SECTION 00902

ADDENDUM NO. 2

This addendum modifies the Contract Documents dated March 17, 2020, for the San Lorenzo Valley Water District Lyon and Big Steel Pipelines Improvements Project, and the work shall be accomplished in accordance with such modifications. This Addendum includes two (2) pages plus six (6) attachments (total of 27 pages).

Lyon & Big Steel Zone Pipeline Improvements

C6.2
SHEET 24 OF 27

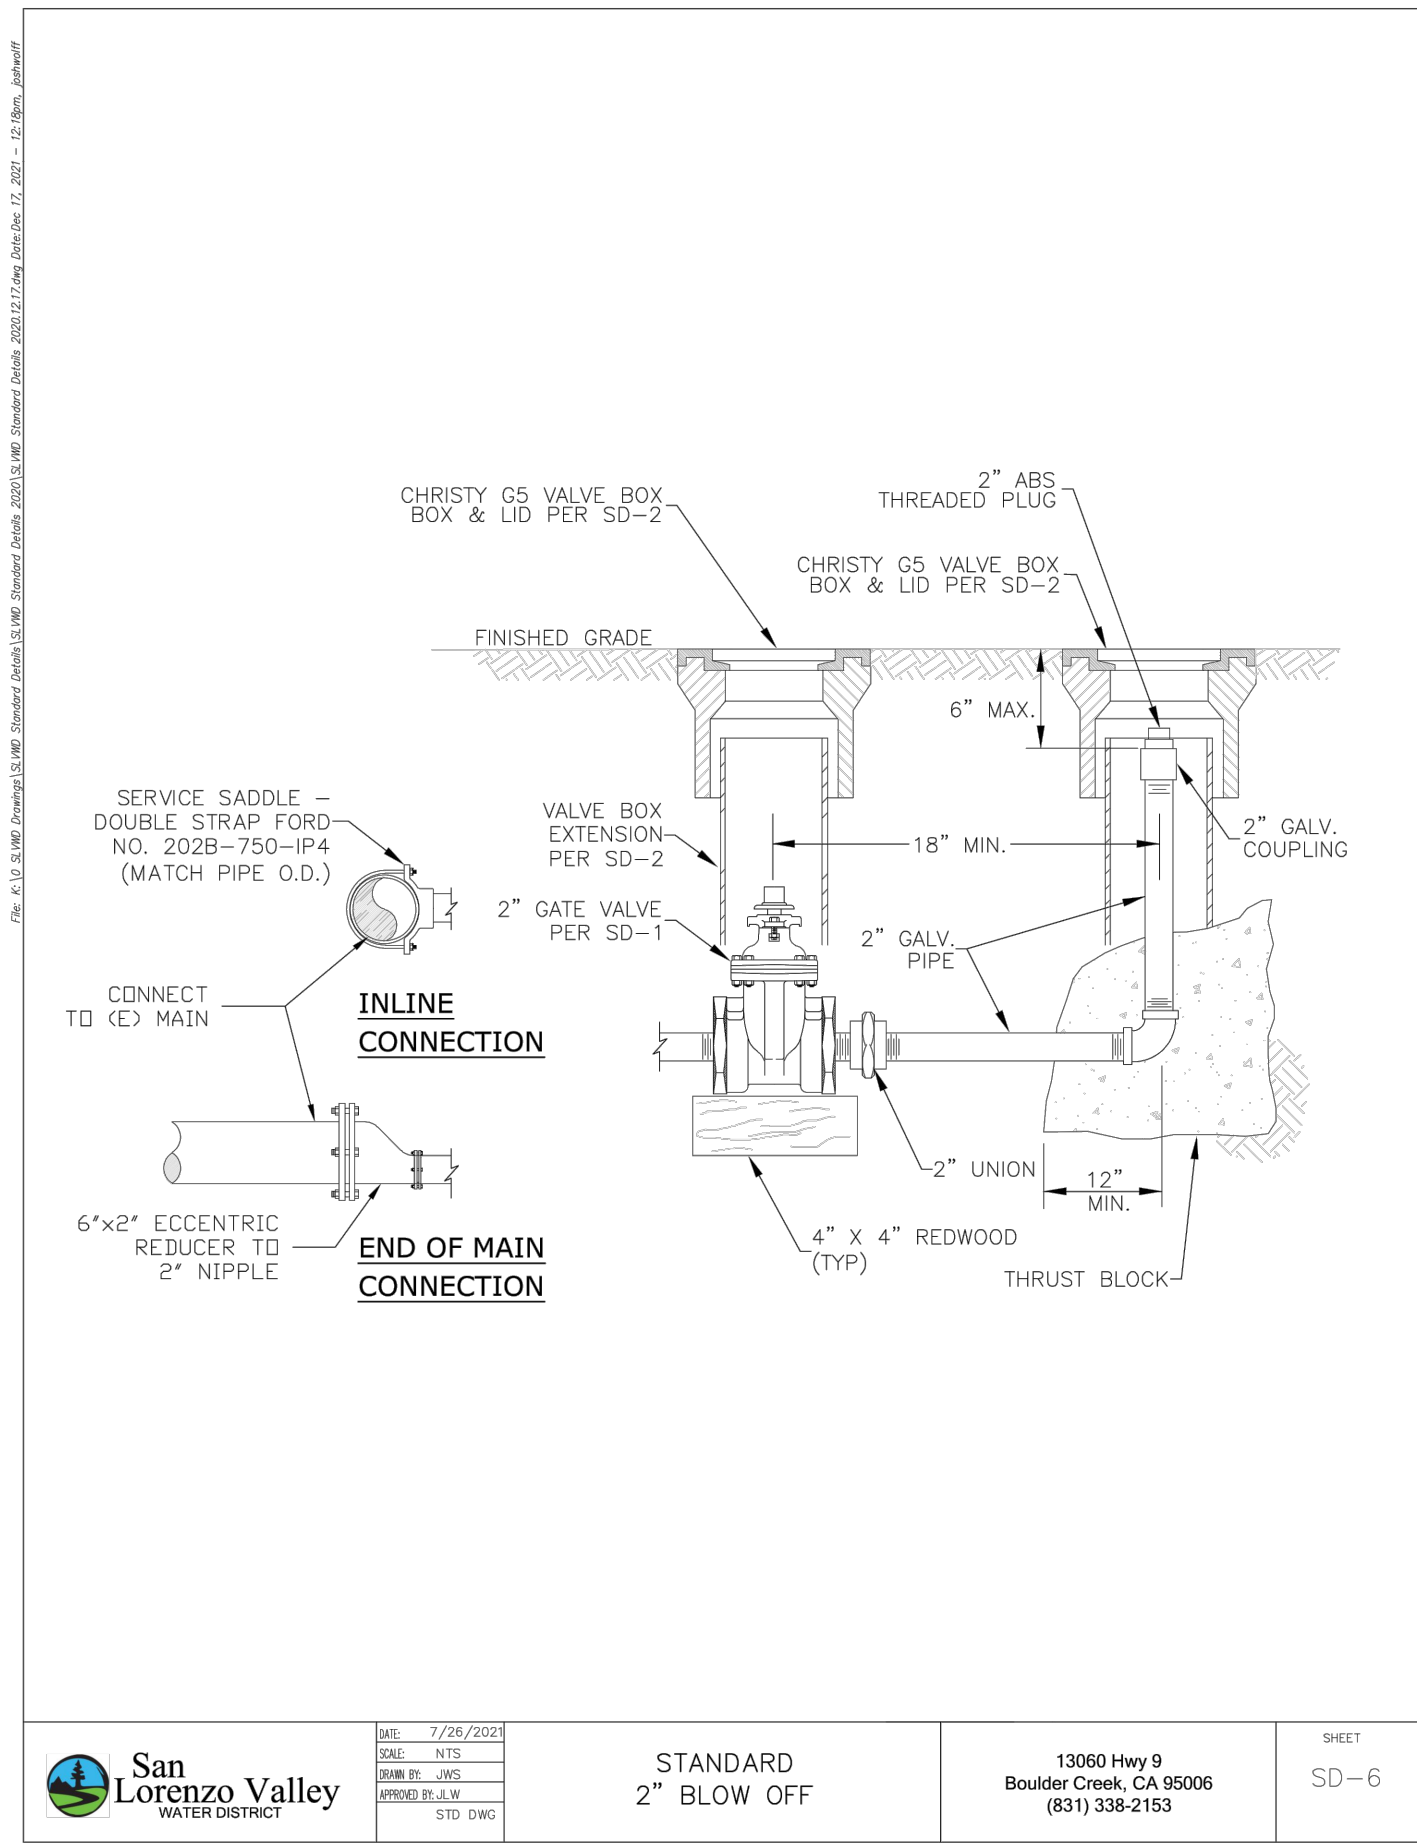
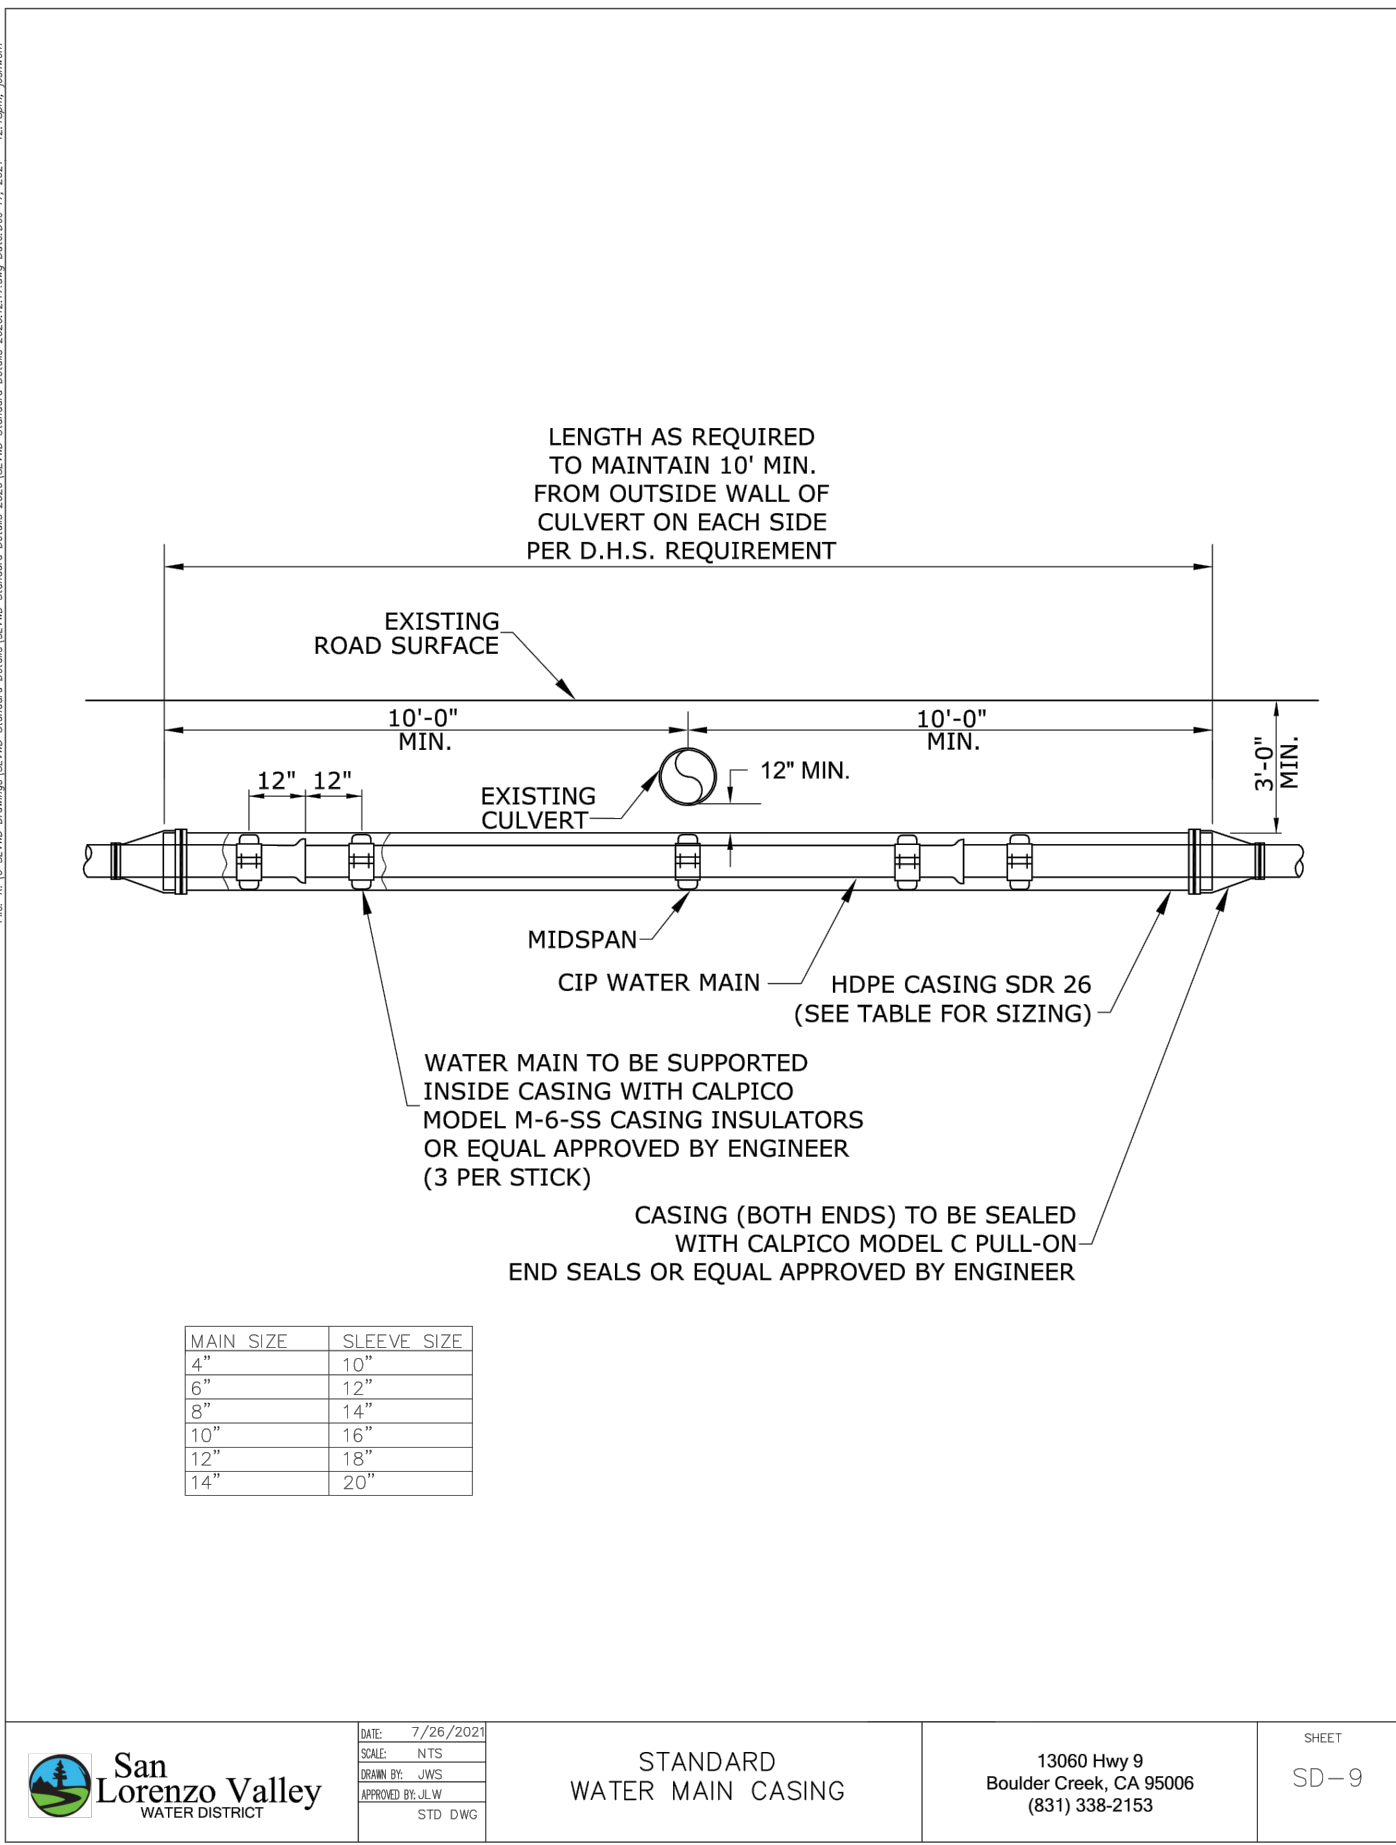
- A. Sheet C4.9, Detail P is revised to call out the Lorenzo Street PRV Vault. The changed sheet is attached.
- B. Sheets C6.2 and C6.3 are revised to add the latest Santa Cruz County Encroachment Permit Details. The changed sheets are attached.

- a. Trench repairs require hot mix asphalt concrete for the trench and trench cap. Slurry seal of the trench cap and adjacent pavement is required to the limits set in the encroachment permit. The County's most recent encroachment permit detailed are attached.
